# Charlotte Street Revitalisation Cooktown

## Community Feedback Summary and Final Concept Plans

SHEET 8 OF 9

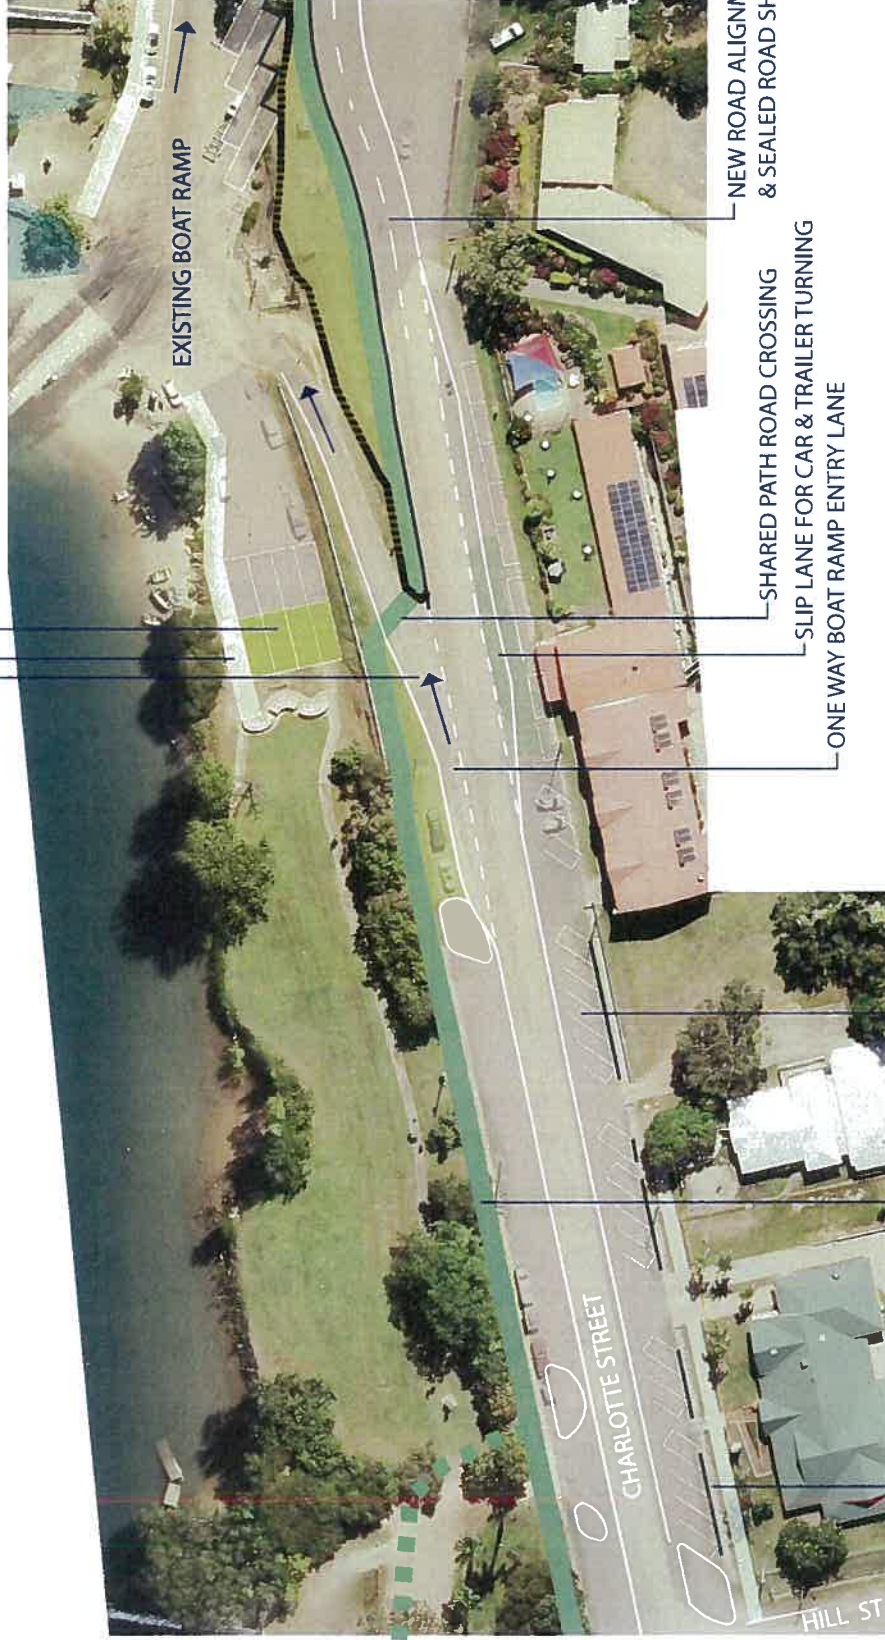
5. All cross-overs to be cohesive in appearance, standard design (1 submission)
6. Provide road separation to achieve 3% fall to gutter (1 submission)

1. Roadway –
  - Charlotte Street roadway more formalized (kerbed) with wide sealed streetscape from roundabout to Hogg Street to reflect remainder of Charlotte Street streetscape
  - Where there are steep drop-offs to heritage kerb and gutter between Bank St and boat ramp access road, proposed to add new concrete kerb to opposite side of heritage kerb to provide an open drain and mitigate drop-off. The new concrete kerb may also be used as a wheel-stop for parking against the drain. Proposed areas for the new wheel stop kerb are shown on Sheets 7-8
2. Intersection Treatment –

SHEET 9 OF 9

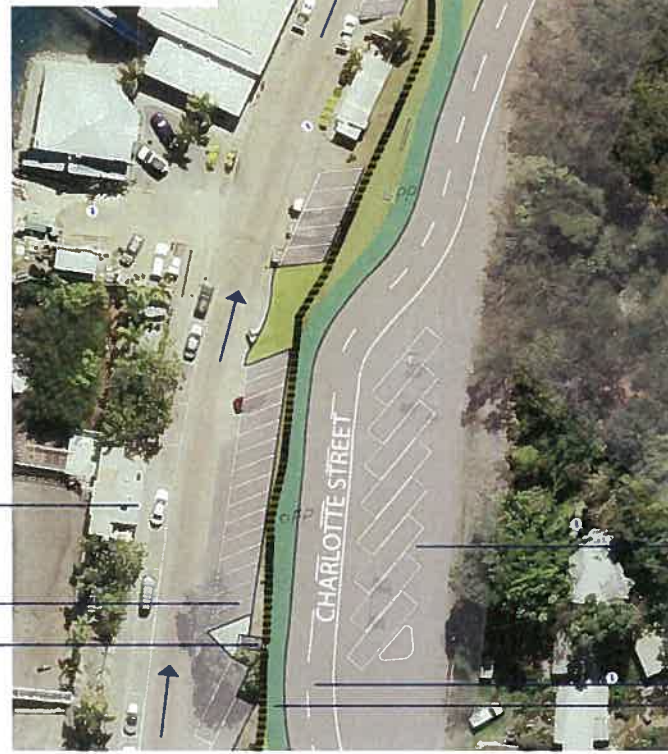
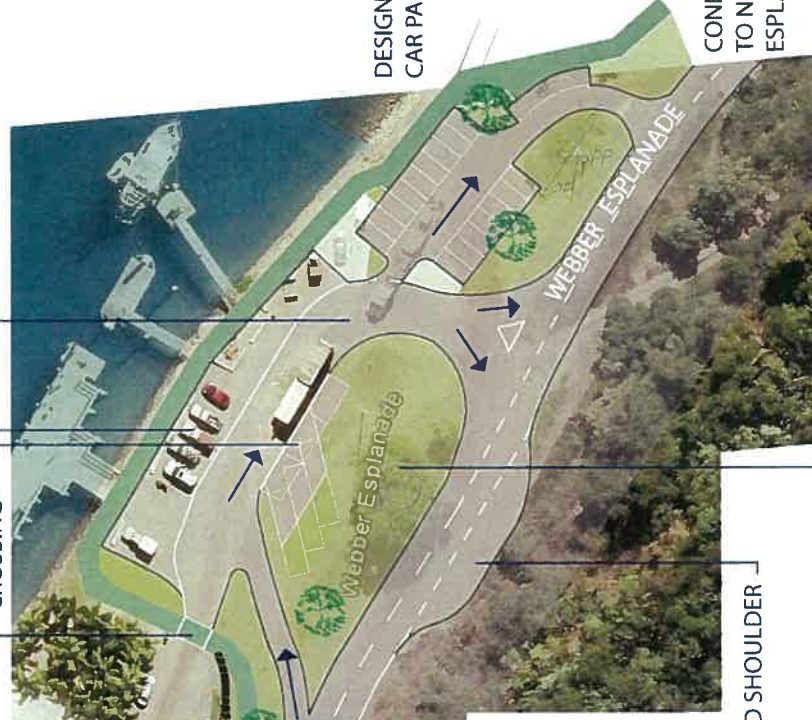
- e) Relocate traffic island at fountain to Banks St bend for safety reasons
2. Of great concern was **Wharf area Treatment**:
  - a) Loss of turnaround area at wharf for larger vehicles which use this now

- b) One way road would be congested with mixed-use vehicles
  - c) Concern over reverse boat trailer parking, request for drive in-drive out boat trailer parking

- d) Reduce trailer & boat parking for aesthetic/ beautification reasons Vs increase car parking in this area
  - e) No parking at 'Tree of Knowledge'

- f) Increase boat trailer parking Vs move this further away Vs boat trailer parking closer to the boat ramp
  - g) Extend loading area at the jetties

- h) Provide traffic calming speed bumps to Webber Esplanade
  - i) Request angle and not 90 degree parking along the one way roadway
3. Entry Roundabout:

- Intersection line marking to allow for one lane only cueing/ turning in accord with traffic engineering practice
3. Wharf Area –
- Heavy vehicle turnaround provided similar to current arrangement (refer Sheet 9 of concept drawings)

- Remove proposed 7 x boat trailer parking proposed Session 2, utilise this area for 3 x boat trailer parking or vehicle parking to allow heavy vehicle turnaround, with added open space to Tree of Knowledge

- Loading area extended to front of jetties
  - Provide in-out 8 x boat trailer parking to top of street where 10 x boat trailer parking proposed Session 2 concept drawings

- Angle and not 90 degree parking in this area along lower service road
4. Parking
- Wheel stops as appropriate to Charlotte Street
  - Provide appropriate loading areas, bus stops, disabled parking
